# Technical Review of the CENWP Computational Fluid Dynamics Model of the John Day Dam Forebay

Prepared for  
US Army Corps of Engineers, Portland District  
Portland, OR

This document provides a technical review of the CFD model developed by USACE personnel for the John Day forebay. The review consists of evaluating the computational mesh and model configuration, validation, and application.

**Figure 3.1.** Comparison of Vectors from ADCP Measured Velocity, CENWP MARS Modeled Velocity, and the CENWP UD Model at an Elevation of 254 ft (top) and 244 ft (bottom)

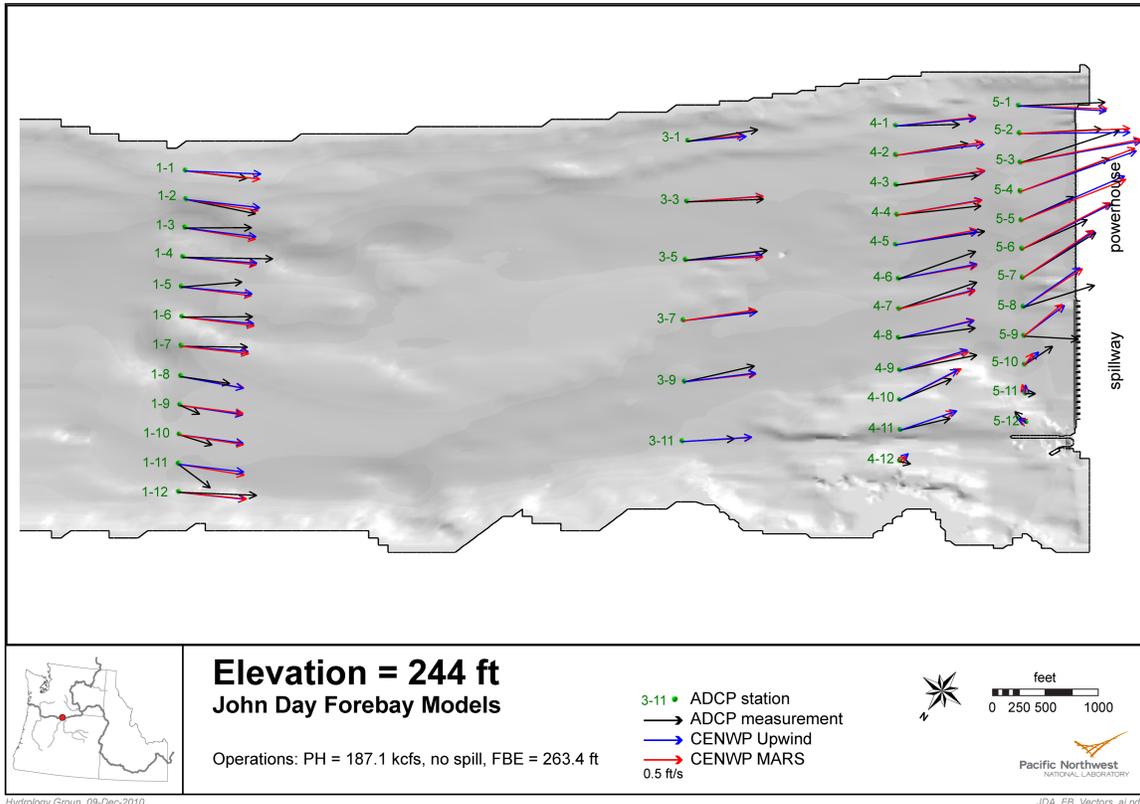
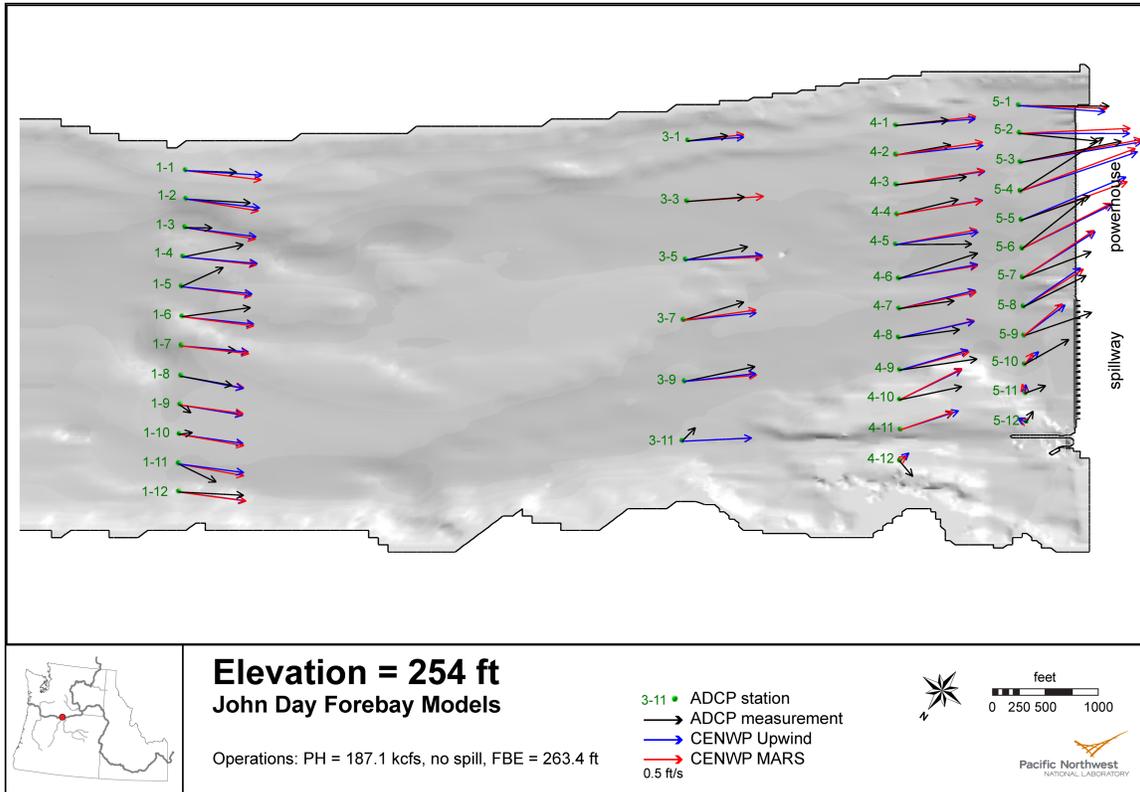
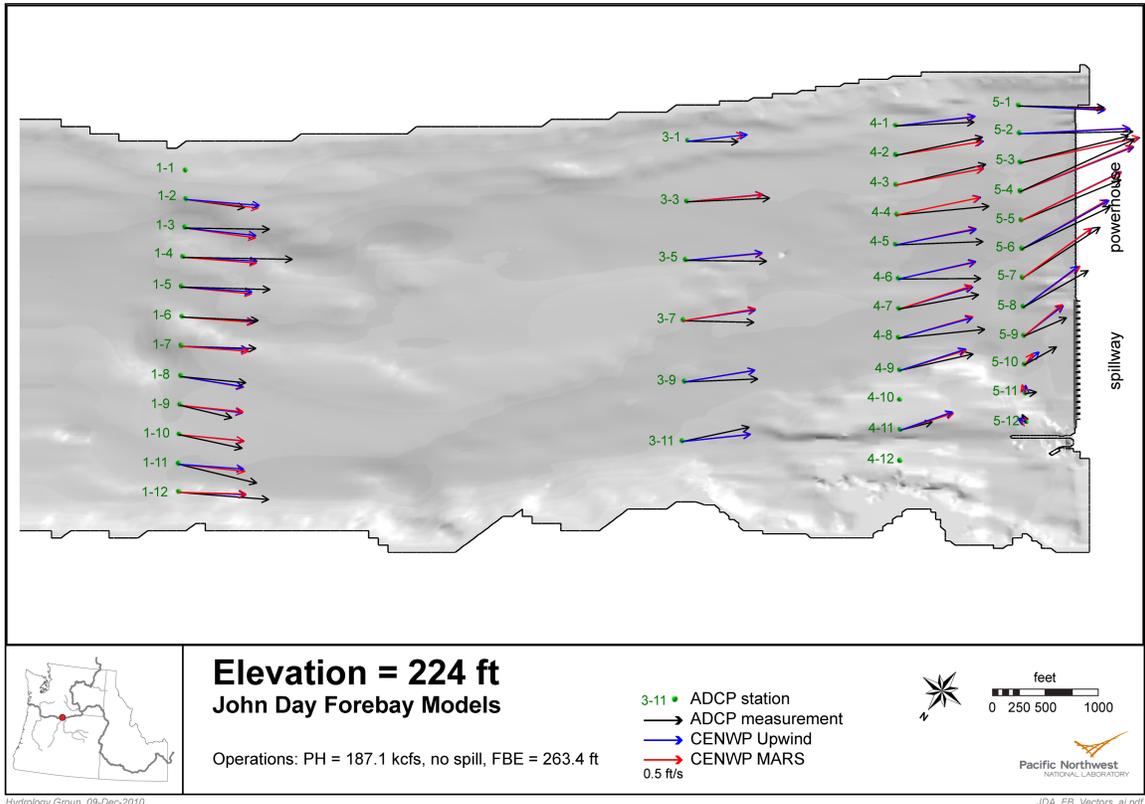
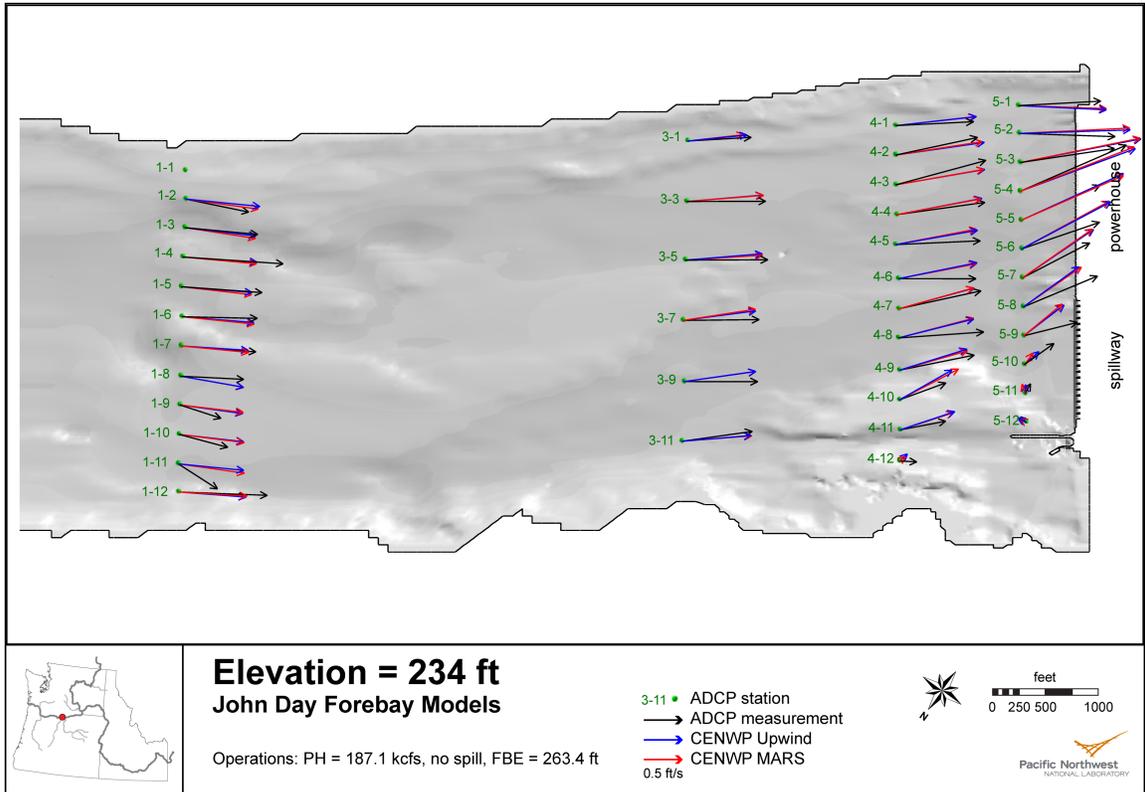
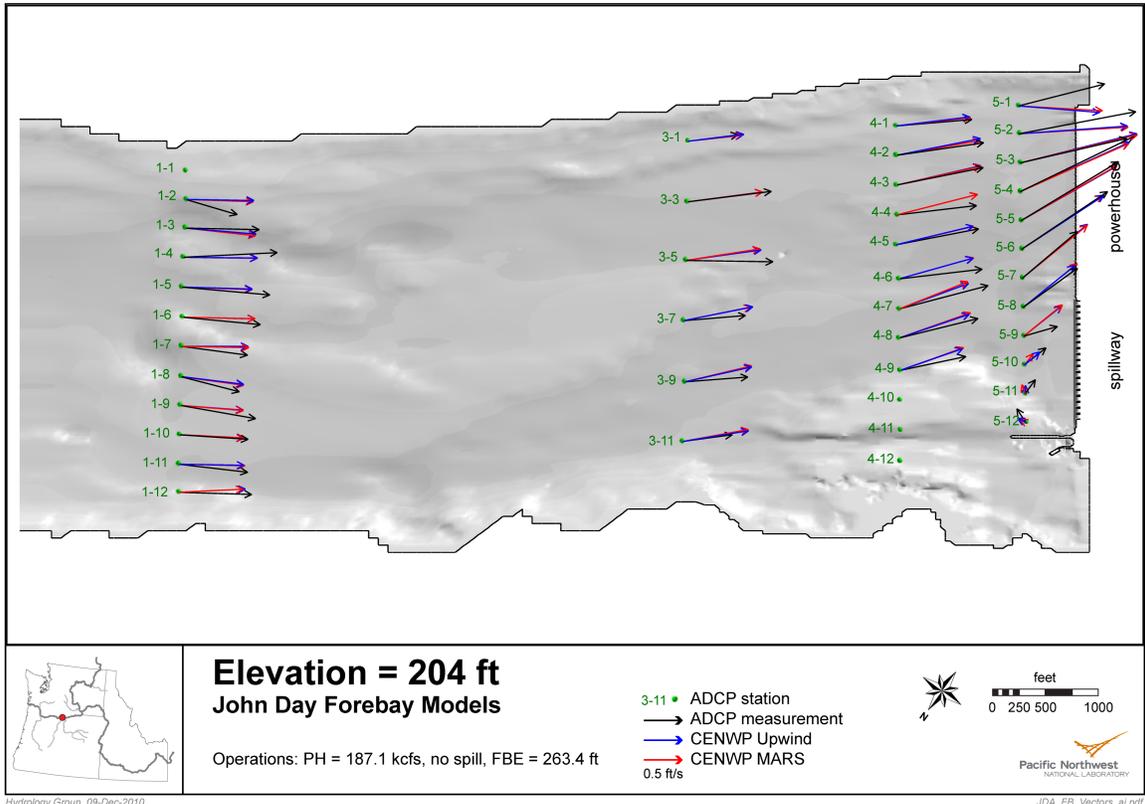
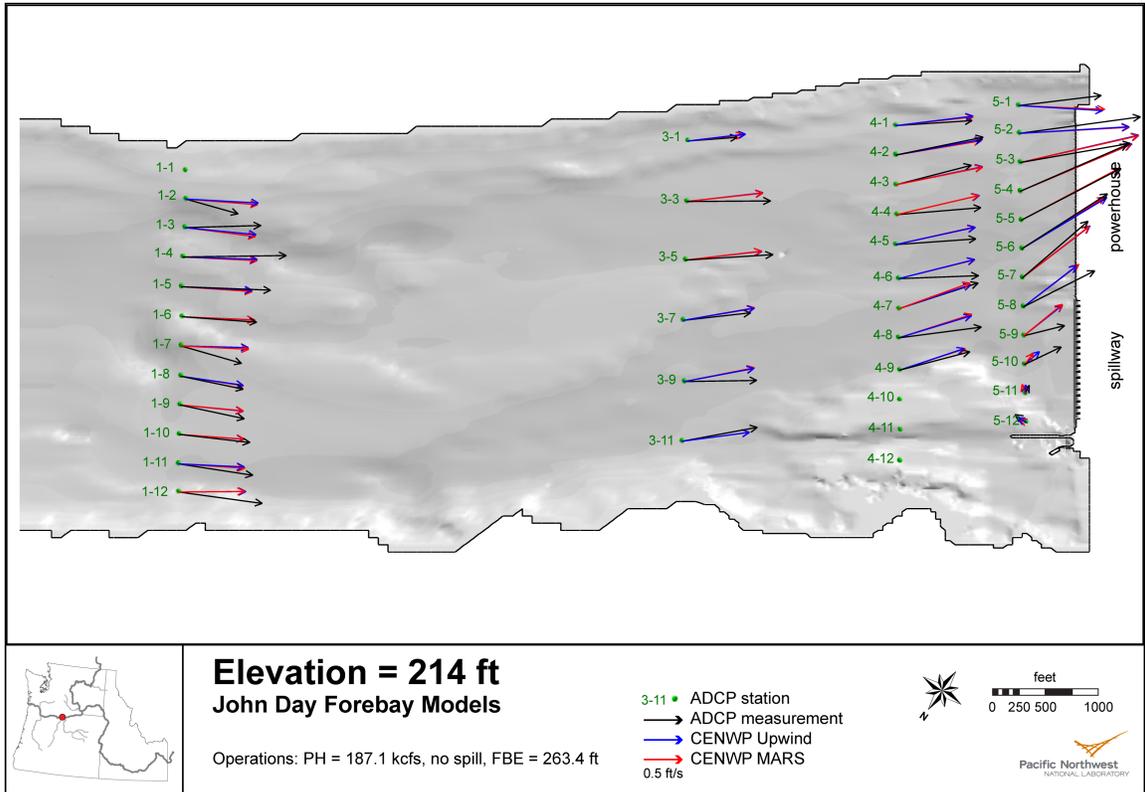
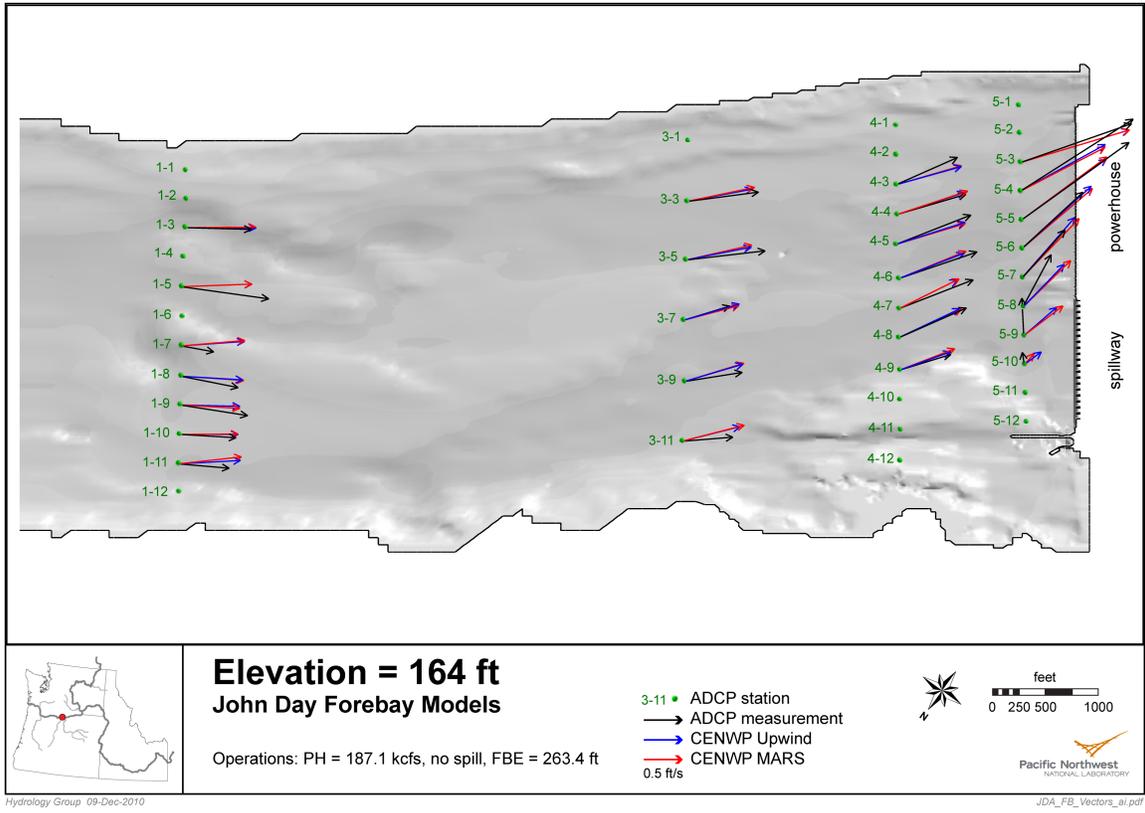
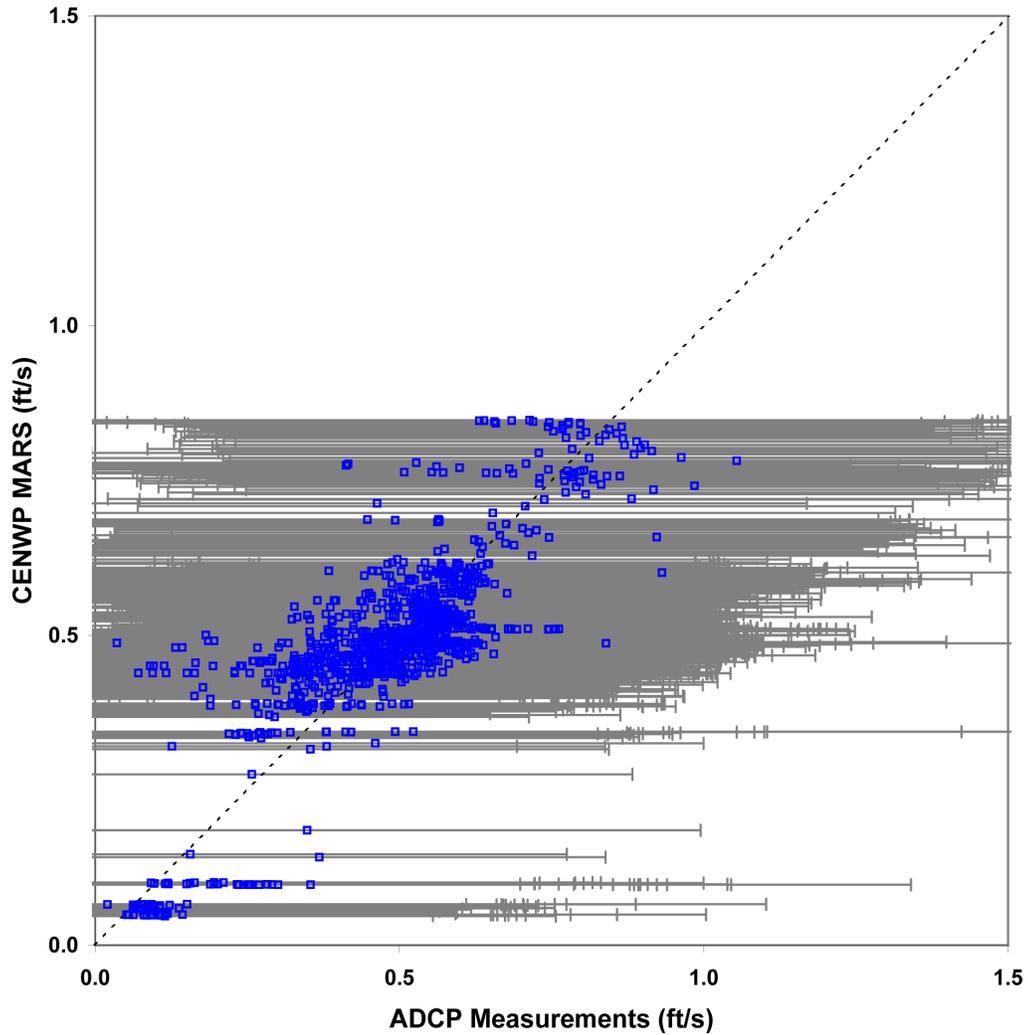
Figures 3.1 to 3.4 show the velocity vectors at the ADCP measurement points for the measured velocities, the CENWP model with MARS, and the CENWP model with UD. These are ordered from the near water surface (Figure 3.1), then down through the depths.

Note that the results for both differencing schemes were very similar for all ADCP points, the match to the measured data was worst at the most upstream (near the inflow boundary, especially in the upper bins) and just upstream of the dam face between the spillway and powerhouse. However, if one considers the large standard deviation for each measurement (shown in the black

error bars in Figure 3.5 and often larger than the velocity magnitude), the measured to modeled velocities are acceptable for the river environment for both differencing schemes. These very large standard deviations indicate that the prototype flows measured were turbulent and transient. A steady-state numerical model will not capture these features.

**Figure 3.6.** Comparison of Vectors from ADCP Measured Velocity, CENWP Modeled Velocity, and the CENWP Model as Refined by PNNL at an Elevation of 254 ft (top) and 244 ft (bottom)

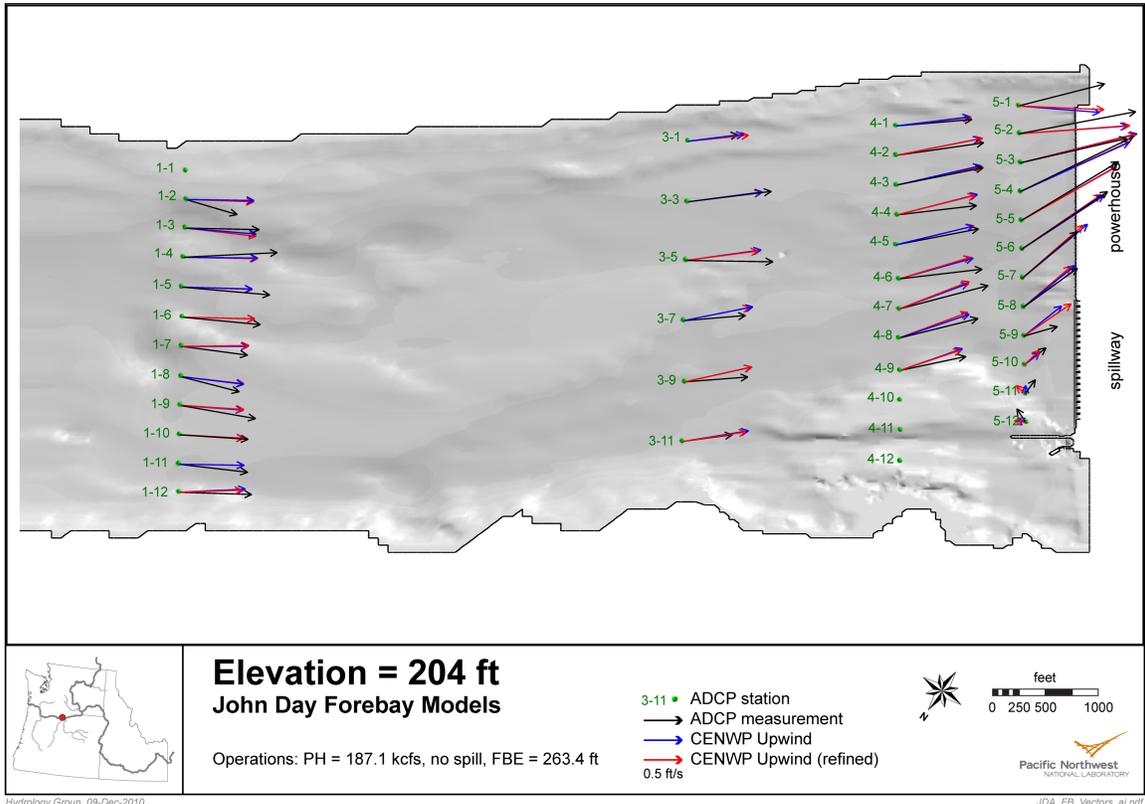
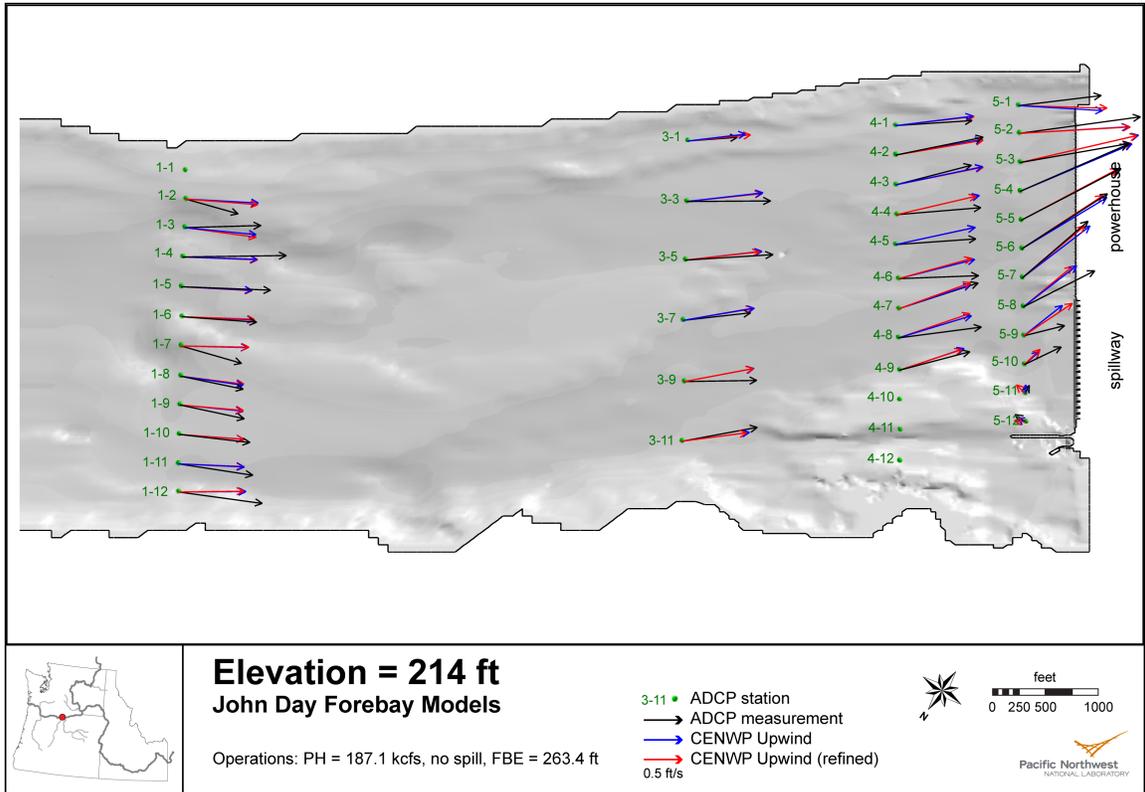
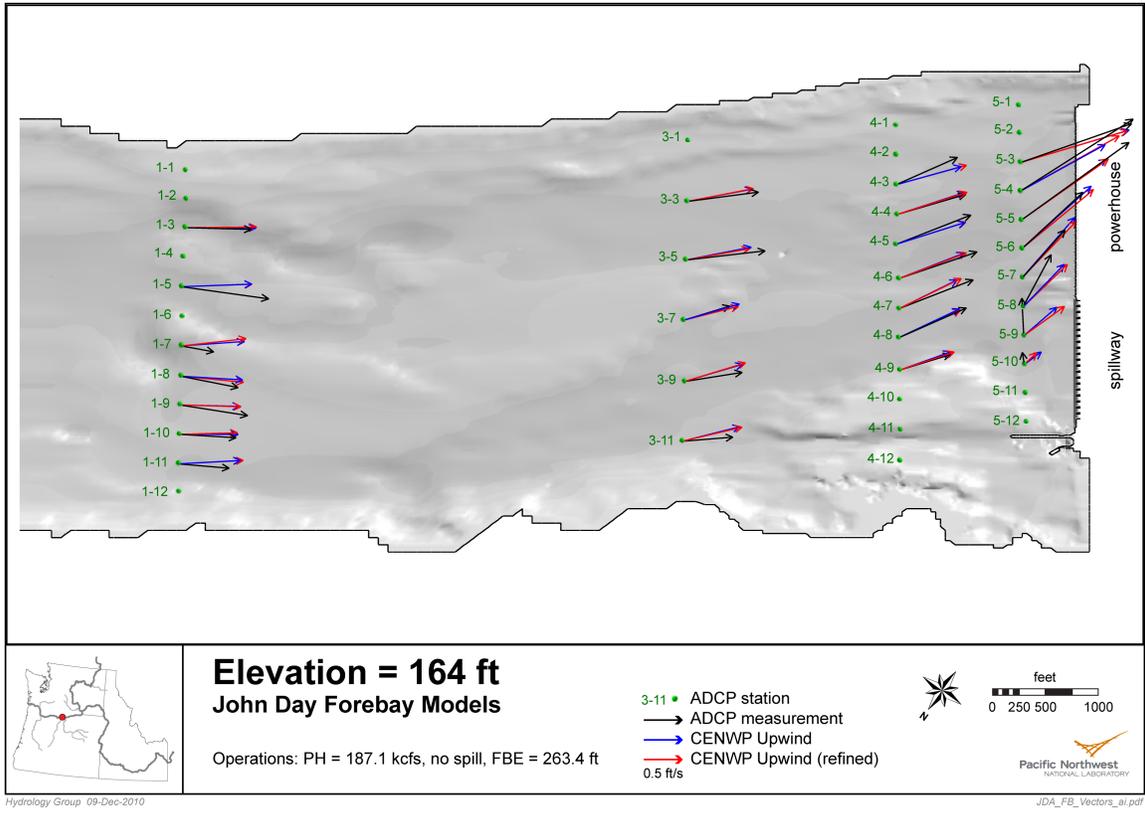
We tested if there were differences between the CENWP model and a refined version of that model (Figures 3.6 to 3.9). The CENWP model and refined model results were almost identical in the upstream portions of the model although they have different flow directions near the powerhouse. It should be noted that the unrefined model was more similar to the field-measured data for the velocity measurement points nearest the powerhouse.

Judgment needs to be used when applying these numerical models. A steady state model with a rigid lid will capture the overall flow patterns of the forebay, but is not intended to capture the transient nature of prototype flows. It does, however, capture the overall flow patterns and areas of recirculation. These comparisons are about the same as the validations results at the forebays of projects such as The Dalles Project and Bonneville Project.
